66 GRAYSON PLACE SANFORD

FIRST FLOOR COMMON AREA RENOVATION SCOPE

Reference: Engineering Services
66 Grayson Pl.
Sanford, NC 27336
TE&D Project No.: 2201-020030

Item #1: Wall to be Removed

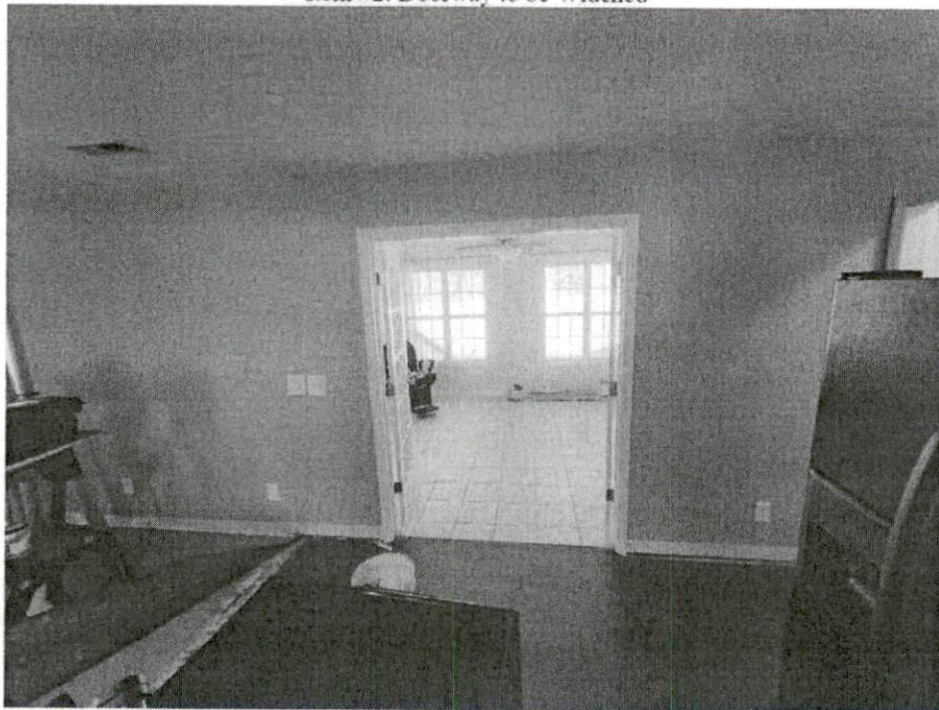
- 1) We understand the new opening is to be approximately 11'-3" wide. Based on our observations and analysis, the wall to be removed is considered load bearing as it supports the floor and wall above. The new opening is to be framed with a minimum (2) 1-3/4" x 11-7/8" LVL beam with (3) 2 x 4 jacks and (2) 2 x 4 king studs at each end. Stud columns are to be blocked solid to monoslab foundation below.

Note: The proposed beam is to be installed as dropped. The existing floor trusses are not to be altered or damaged for beam installation.
